**ADDENDUM NO. 2**

**KENDALLVILLE PUBLIC LIBRARY RENOVATION  
MAIN AND LIMBERLOST BRANCHES  
MSKTD Project No.: 8045  
May 9, 2025**

**KPL - First Floor Electrical Lighting Plan Unit "B"**  
1/8" = 1'-0"

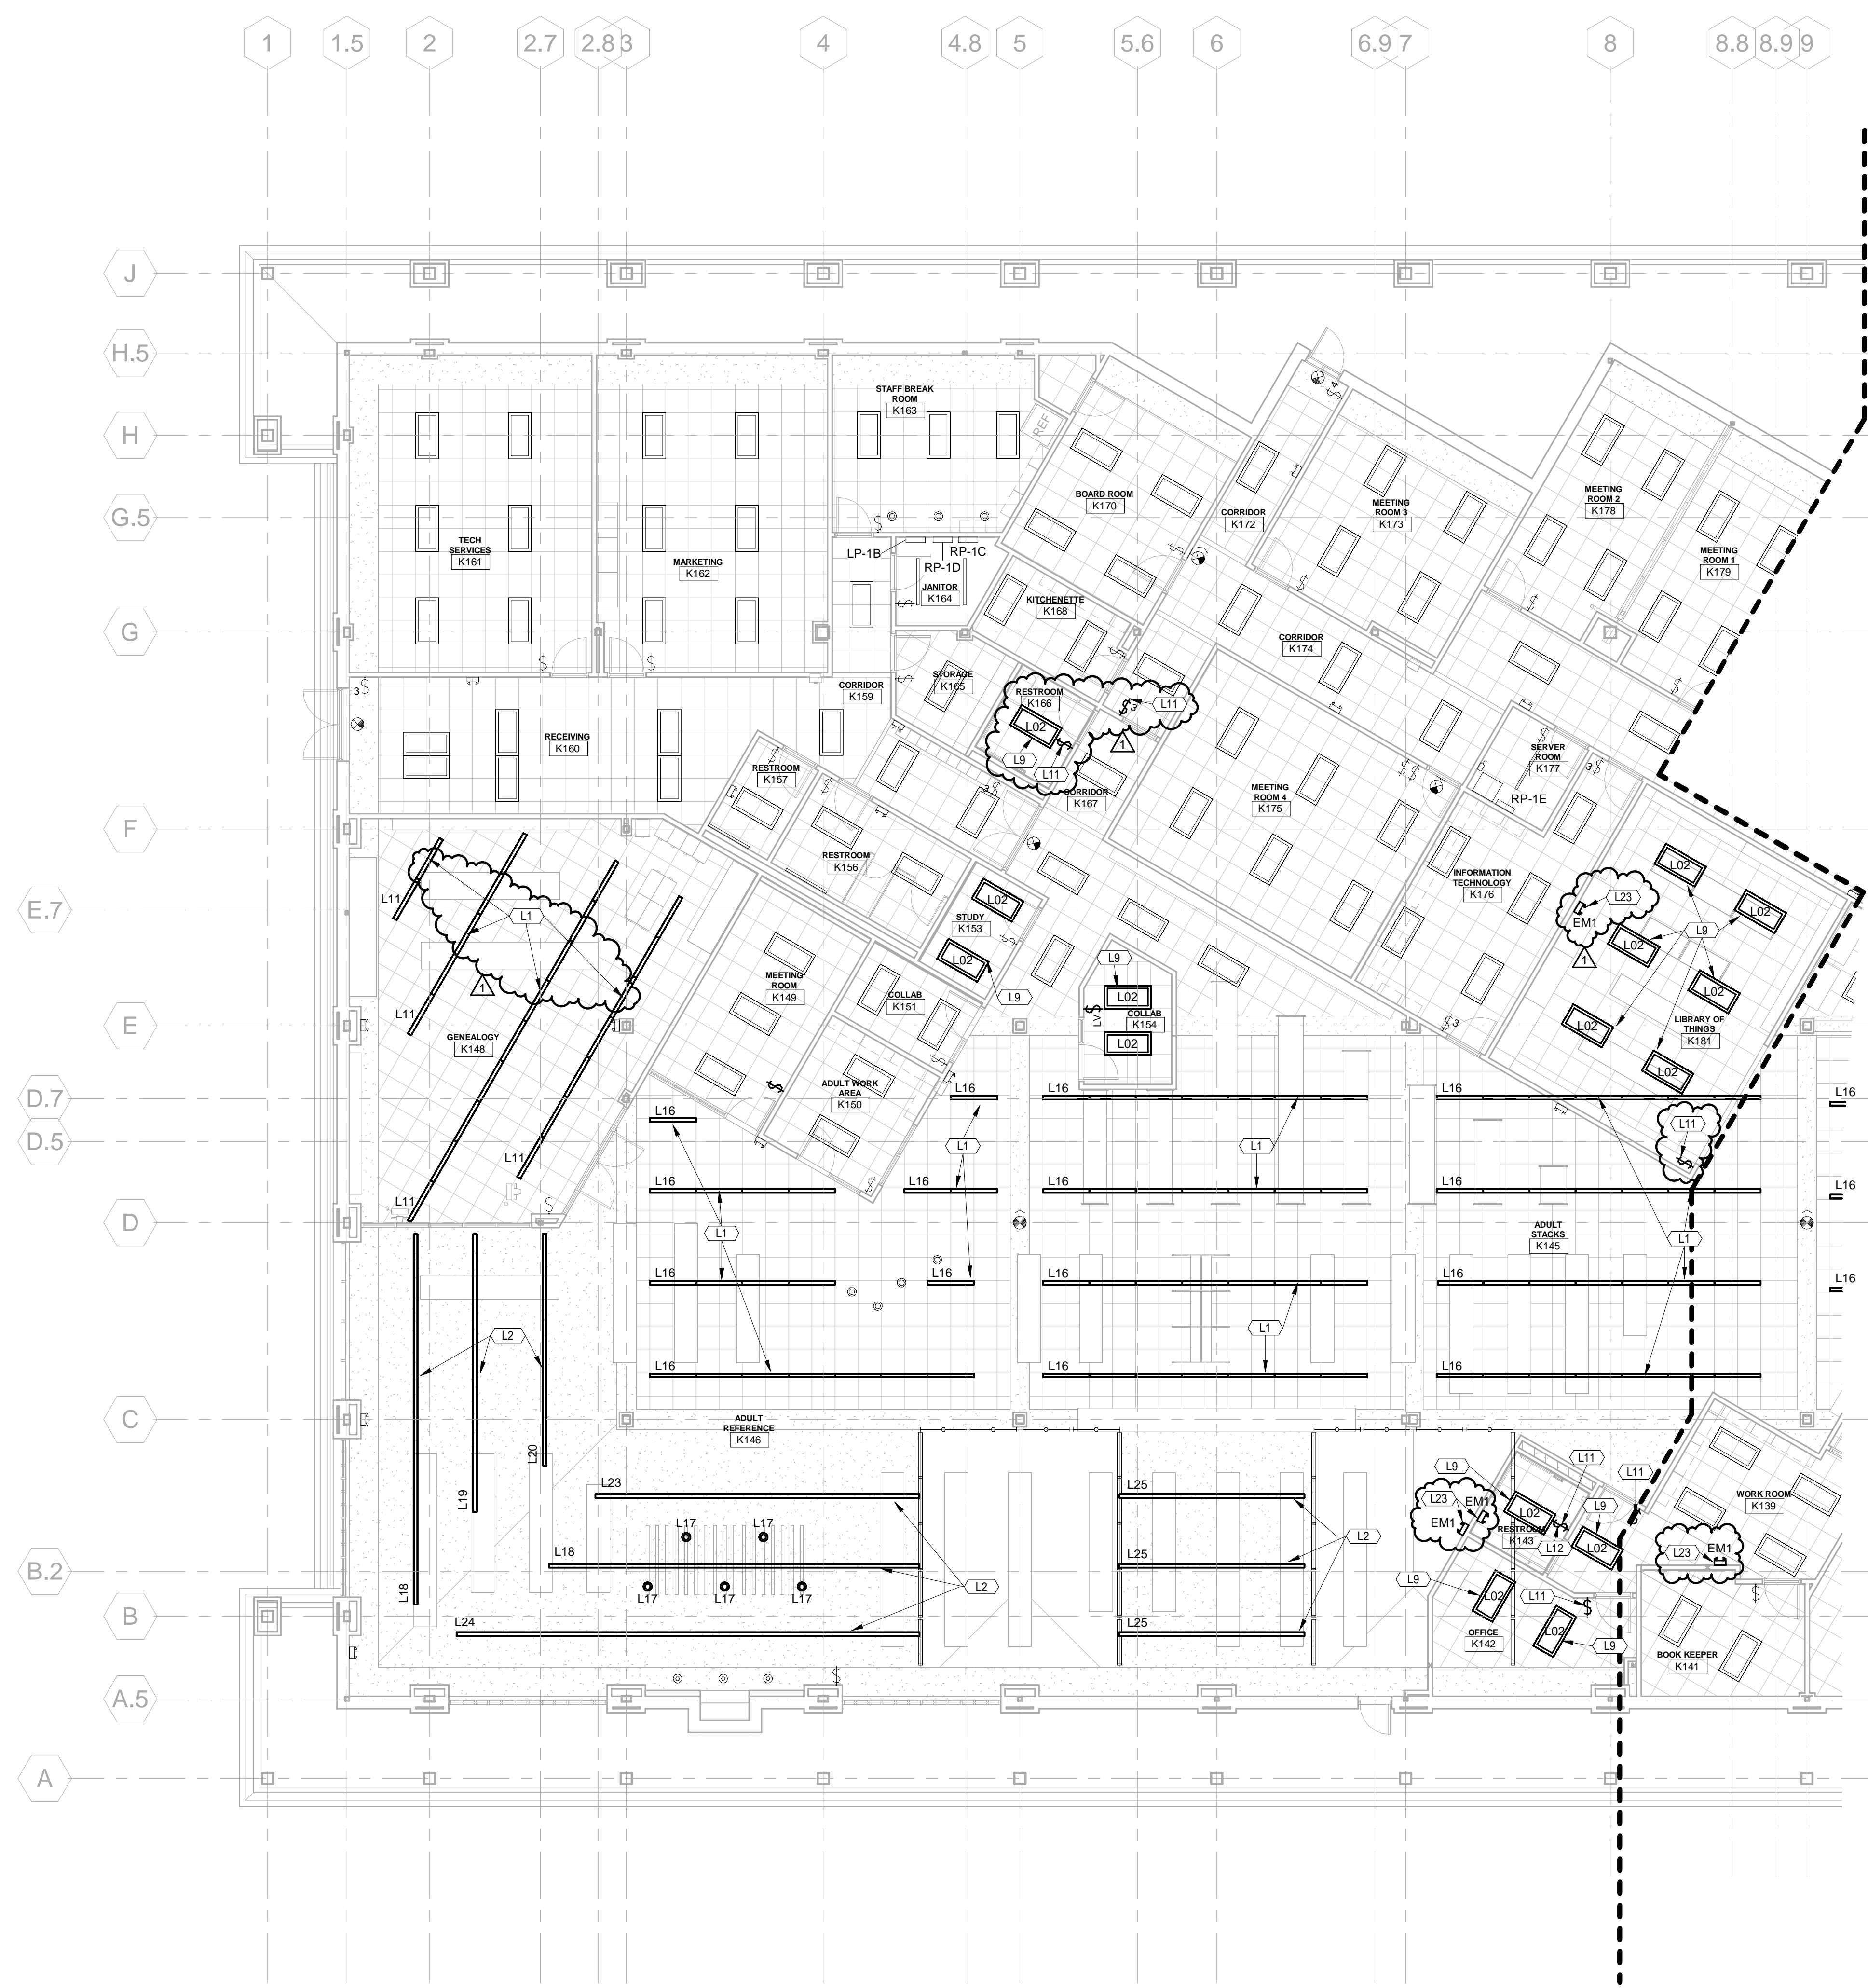
2.11	Drawings Sheet EK301b	<p>Refer to attached, revised sheet EK301b for the following clarifications/revisions:</p> <ol style="list-style-type: none"> <li>1. In Workroom K139, Restroom K143 and Adult Stacks K145 show EM1 lights and added Lighting plan note L23.</li> <li>2. In Genealogy K148, add Lighting Plan Note L1 on light fixtures.</li> <li>3. In Library of things K181, add EM1 and new light switch.</li> <li>4. In Restroom K166 add Lighting plan notes L9 and L11.</li> <li>5. In Corridor K172, add Lighting plan note L11 on new light switch.</li> </ol>

**LIMB - First Floor Electrical Lighting Plan**  
 1/8" = 1'-0"

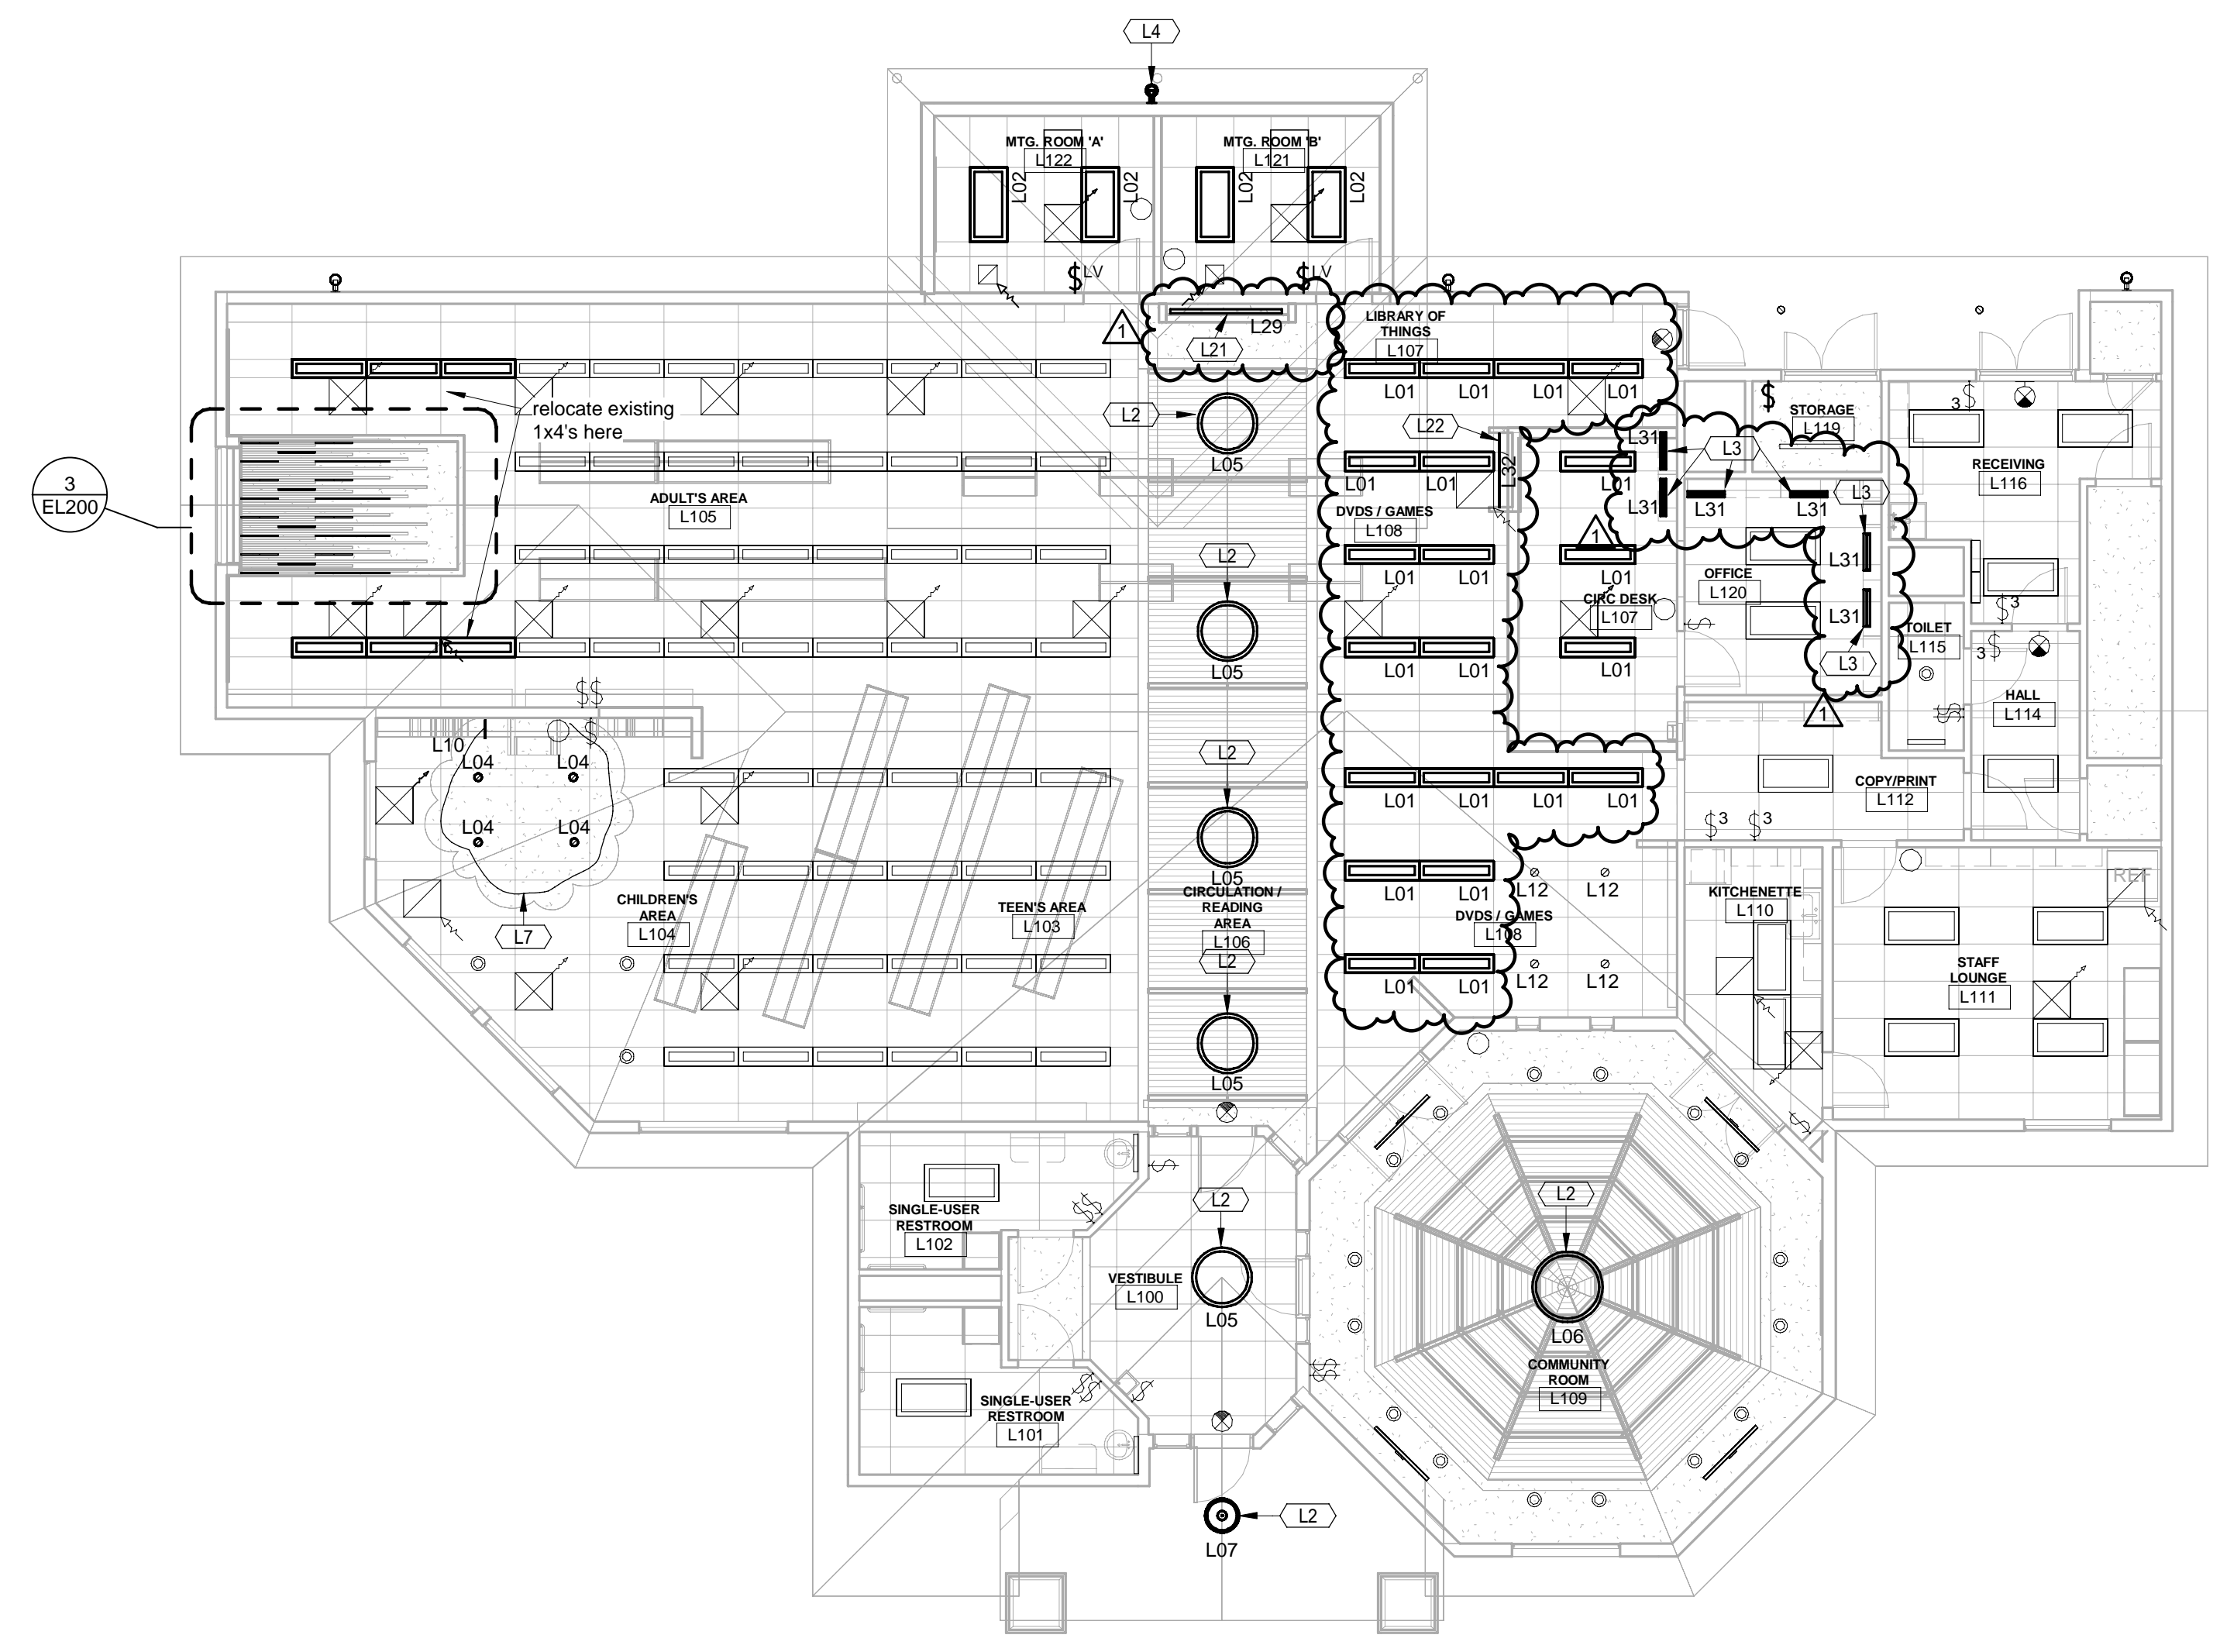
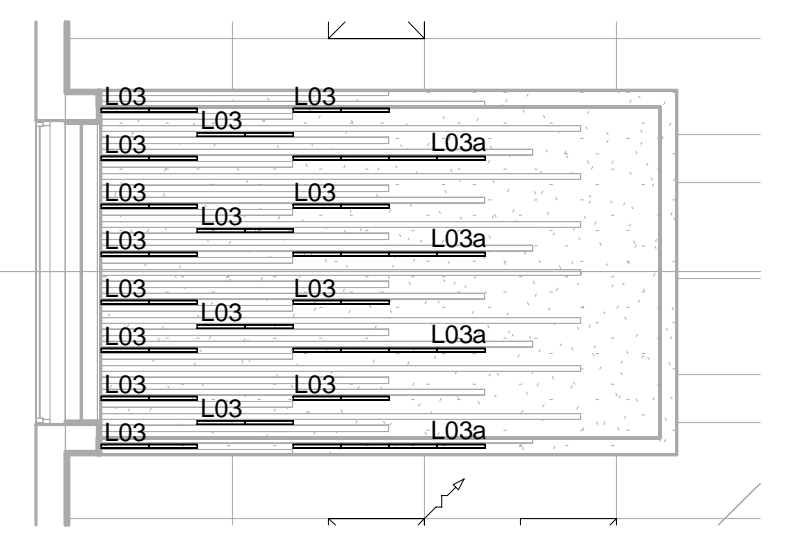
<u>ITEM</u>	<u>LOCATION</u>	<u>DESCRIPTION</u>
2.12	Drawings Sheet EL200	Refer to attached, revised sheet EL200 for the following clarifications/revisions: <ol style="list-style-type: none"> <li>1. Revise lights and L01 tags in DVD/Games L108.</li> <li>2. Add (1) L29 light fixture and (1) switch on west wall outside of Mtg Room "B". Add Lighting Plan note L21.</li> <li>3. Add (4) L31 lights under wall cabinets in Office L120. Add Lighting plan note L3.</li> <li>4. Add (2) L31 lights under wall cabinets in Circ Desk L107. Add Lighting Plan note L3.</li> <li>5. Added (1) L32 light in glass display at circ Desk L107. Add Lighting Plan note L22.</li> </ol>

- L22 INSTALL NEW L32 LIGHT FIXTURE. FIXTURE SHALL BE SURFACE MOUNTED INSIDE GLASS DISPLAY CASE. REFER TO ARCHITECTURAL DETAIL 2 & 8 ON SHEET ALSO. EXTEND EXISTING AREA LIGHTING CIRCUIT TO THIS NEW LIGHT LOCATION. LIGHT SHALL BE CONTROLLED BY EXISTING AREA LIGHTING CONTROL. MOUNT DRIVER IN ACCESSIBLE SPACE IN BASEMENT AND ROUTED CABLING THRU POKE THRU.
